### CHANGE IN THE DIFFERENTIALS IN THE 13/16 TON RIGID DRIVE AXLES

**2. Changed Items in DP-330 Differential Carrier Assy:**

Picture 1. Earlier design up to S/N 144392

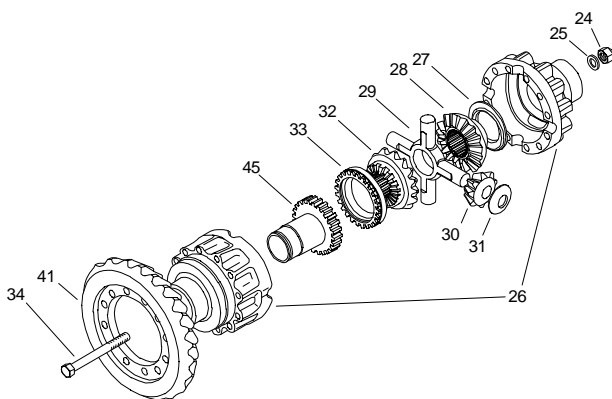
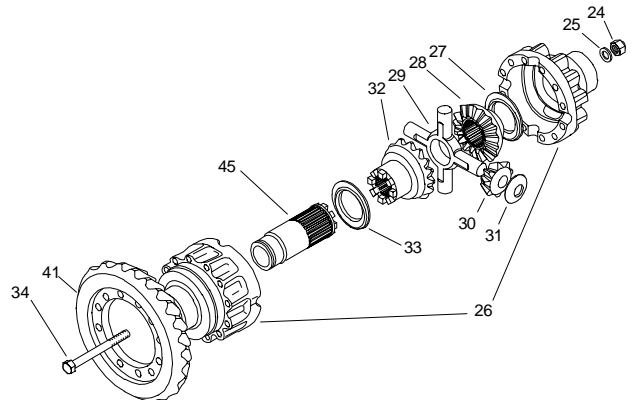
**1. Change:** The axle shaft splines in the new (approx 2005 onwards) 13/16 ton rigid drive axles have changed causing also that the splines in the differential side gears have changed simultaneously. In the through drive differential carrier assemblies MP-330 (in fore most tandem axles FRMP-13/16-S) and FP330 (in tridem axles FRFP-13/16-S) only the side gear splines have been changed. In differential carrier assembly DP-330 (in the rearmost tandem/tridem axles FRDP-13/16-S) also the design of differential have been changed to be now almost similar than in the through drive differentials.

(See picture 1. for the earlier version and picture 2. for the later version.)

|      |                 | Up to S/N 144392 | Since S/N 144393 |
| Pos. | Description     | Old Part No.     | New Part No.     |
| 25   | Washer          | 099-601-8110     | -                |
| 26   | Diff. Case Assy | 143-310-2711     | 543-310-4811     |
| 28   | Side Gear       | 143-351-0900     | 543-351-4210     |
| 32   | Side Gear       | 143-351-1410     | 543-351-4310     |
| 33   | Thrust Washer   | 143-357-0000     | 090-359-7000     |
| 34   | Hex Screw       | 099-116-3230     | 599-116-3250     |
| 45   | Sliding Gear    | 144-341-0900     | 144-341-1700     |

**4. Date of Change and Interchangeability:** Since axle S/N 144393 (November 2004) the differentials are later design. The earlier and later differential carrier assemblies are interchangeable only if the changed parts will be changed simultaneously. See the proper maintenance manuals if conversing the differentials. If possible also the tag plate should be changed when conversing a differential.
